Subject: **Docket Nos. 50-361 and 50-362**
Proposed Change Number NPF-10/15-514
Increase in Reactor Power to 3438 MWt
San Onofre Nuclear Generating Station
Units 2 and 3

**DESCRIPTION AND NO SIGNIFICANT HAZARDS ANALYSIS
FOR PROPOSED CHANGE NPF-10/15-514
San Onofre Nuclear Generating Station Units 2 and 3**

Proposed Change Number 514 is a request to revise the licensed Rated Thermal Power (RTP) for the San Onofre Nuclear Generating Station (SONGS), Units 2 and 3, from the originally licensed rating of 3390 MWt to 3438 MWt.

Figure 2-1, Block Diagram

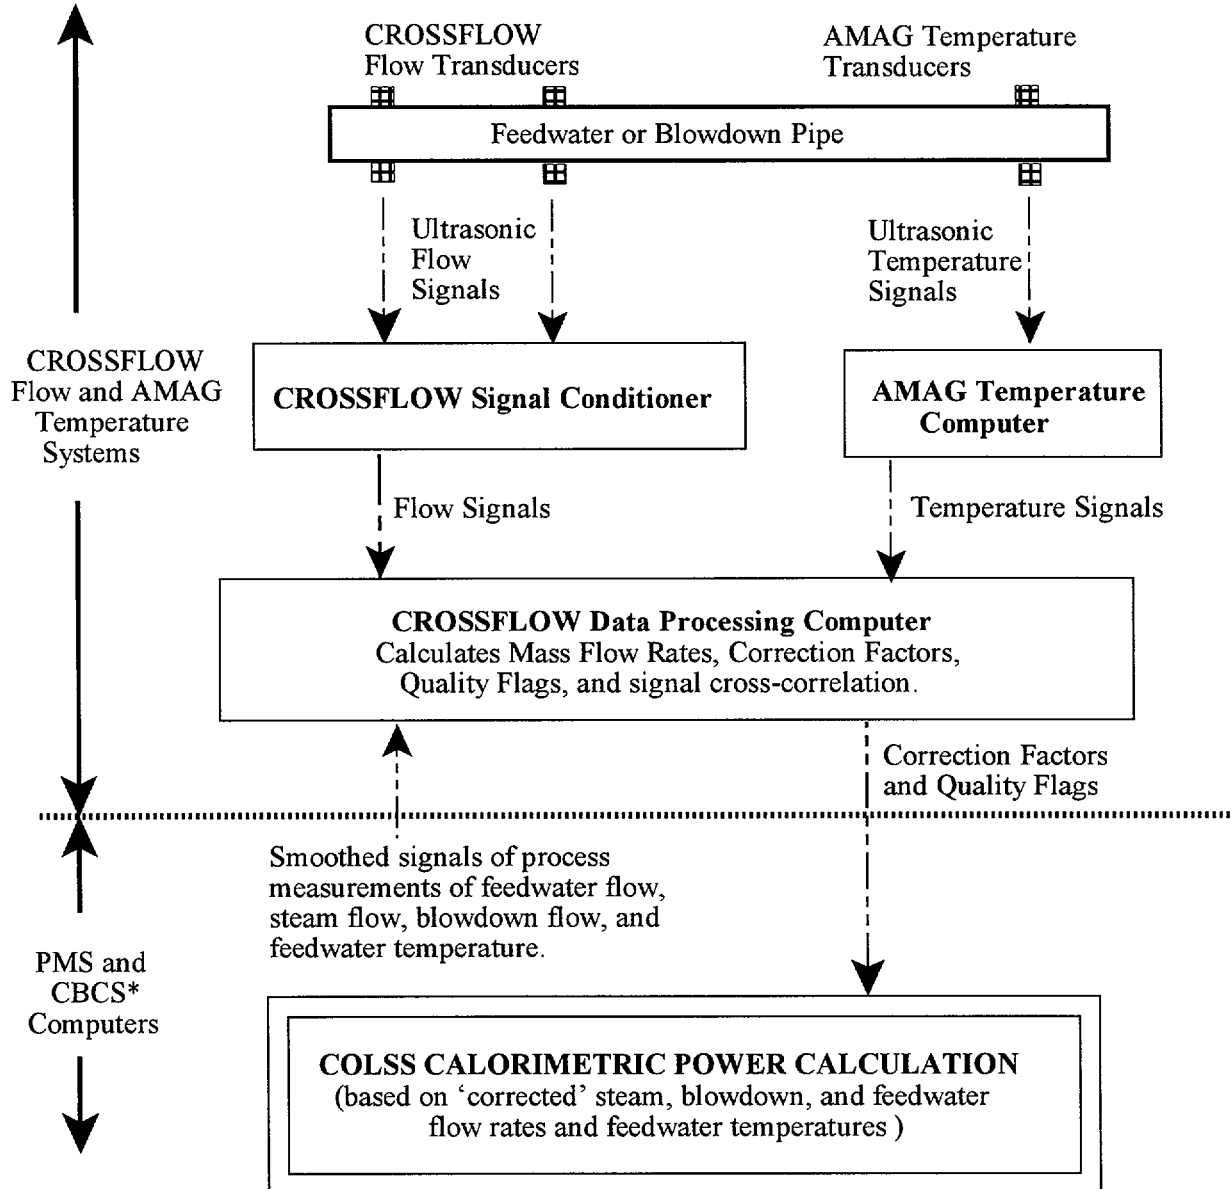
The Westinghouse CROSSFLOW (reference 8.5) ultrasonic flow measurement system (UFM) is used in conjunction with the AMAG high-accuracy ultrasonic temperature measurement system (UTM) and two plant process computers, the Plant Monitoring System (PMS) and Core Operating Limit Supervisory System (COLSS) Backup Computer System (CBCS), to support the increase in reactor power (see Figure 2-1). Reactor power is calculated in COLSS, which resides in the PMS and CBCS plant process computers, from values (including feedwater flow, feedwater temperature, steam flow, and blowdown flow) that are based on corrections from the CROSSFLOW system. The components and information flow path are shown in Figure 2-1, "Block Diagram of SONGS Ultrasonic Systems and Computers."

Cables from ultrasonic flow and temperature sensors will be routed to signal conditioning equipment and data processing computers located in a non-harsh area. The functions of the CROSSFLOW flow signal conditioning equipment and data processing computer are described in the Topical Report (reference 8.5).

The data processing computer receives smoothed values of process measurements of main feedwater flow, main feedwater temperature, main steam flow, and blowdown flow for each loop from the PMS and CBCS. The data processing computer calculates main steam flow for each steam generator from the difference between the ultrasonically-determined feedwater and blowdown flow rates for that generator. The data processing computer compares long-duration averages of the process measurements to long-duration averages of the ultrasonically-determined flows and temperatures, and produces correction factors for feedwater flow, feedwater temperature, blowdown flow, and main steam flow. The data processing computer also determines if each correction factor is sufficiently valid for use and, if valid, sets its quality flag to "good."

The data processing computer then sends the correction factors and quality flags to the PMS and CBCS. If the quality flags are "good" and the plant is above a minimum power level, the COLSS programs in each computer multiply plant process signals of feedwater flow, feedwater temperature, blowdown flow, and main steam flow by their associated correction factors to produce corrected process values. COLSS then uses the "corrected process values" to calculate reactor power and allows operation up to 3438 MWt. Two separate plant computers, PMS and CBCS, are available to calculate reactor power in COLSS. Under our current COLR values for Linear Heat Rate (LHR) and Departure from Nucleate Boiling Ratio (DNBR), a COLSS out of service condition may preclude full power operation based on Core Protection Calculator (CPC) operating margin.
